## Tasman Bridge improvements

Cycling South and Bicycle Network met with the project managers on 4 October 2024 to see what improvements can be done, taking into consideration the engineering constraints of retrofitting a 60 year old structure.

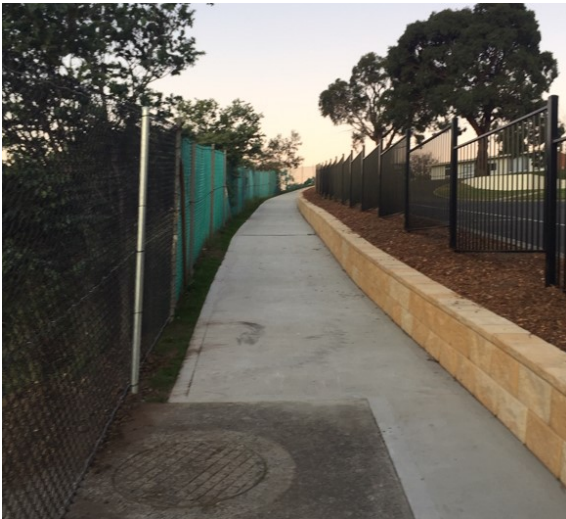
Riawena Road provides another connection to the Tasman Bridge but is only suitable for confident riders due to the awkward camber and narrowness of the road, the risk posed by turning vehicles from the Clarence pool and sports centre for downhill riders and the delay caused to buses caught behind uphill riders where there is inadequate space to overtake due to on-street car parking.

1.8m wide path alongside the Tasman Hwy connecting to Montagu Bay Road.

Riawana Road – a narrow road with awkward camber and high degree of on-street car parking. Also a bus route.

### Western shore access

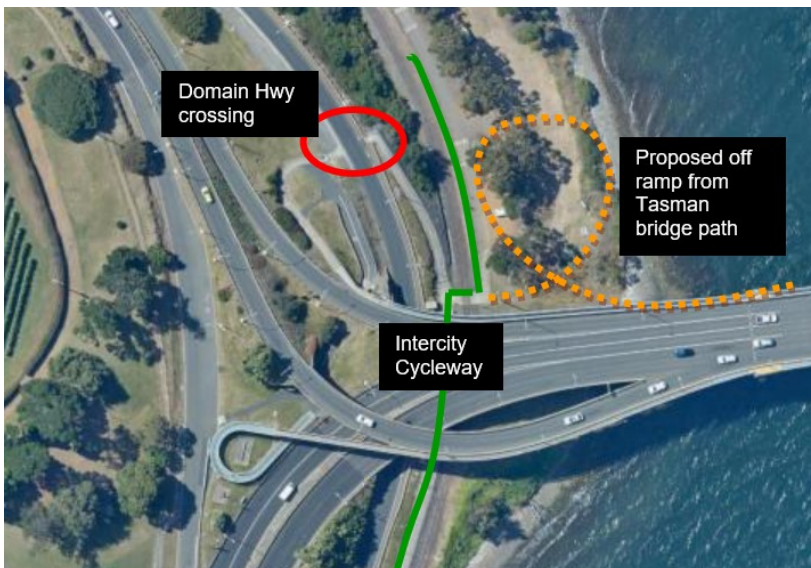
The crossing of the Domain Highway slip lane is of concern to some riders (shown as red circle). An off ramp was shown in the original bridge design on the southern side to connect to the Intercity Cycleway in the Hobart direction. It is preferable for the ramp to be on the northern side which would eliminate the road crossing. Riders on the southern side of the bridge can avoid the road crossing if they prefer by riding a short way along the northern path to access the ramp.

This is considered a lower priority than other proposed improvements as the crossing is only a single lane with traffic coming from one direction. A reduction in speed limit on the Domain Hwy, which has multiple uncontrolled intersections, to 60km p/h would be an acceptable solution.

## One-way pathways

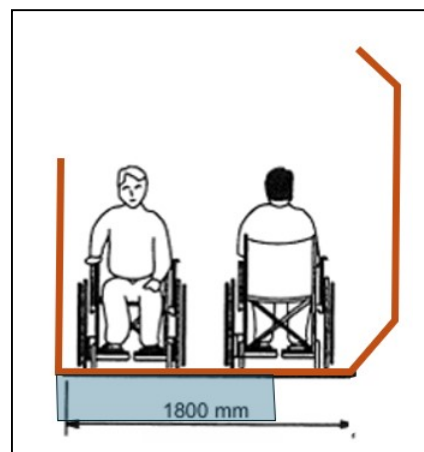
Making each side of the bridge pathways has been mooted to address the narrowness and interactions between riders travelling in opposite directions on the bridge. However the traffic using the pathways is tidal, with the majority travelling east to west in the mornings and west to east in the evenings on weekdays. The movement is more even during the day and on weekends.

The concept of making the pathways one-way is to reduce the inconvenience of having to stop and squeeze past a rider or walker coming in the opposite direction. It does not address getting caught behind slower riders and walkers.

Consideration needs to be given to the inconvenience of riders on the eastern shore having to go under the bridge and ride up a steep hill to get to the opposite side pathway onto the bridge. The additional time and effort added to the journey exceeds the effort of passing someone on the bridge and is not supported by Cycling South. The likelihood of meeting someone on the bridge coming the other way during peak times is minimal, particularly for those riding in the dominant direction.
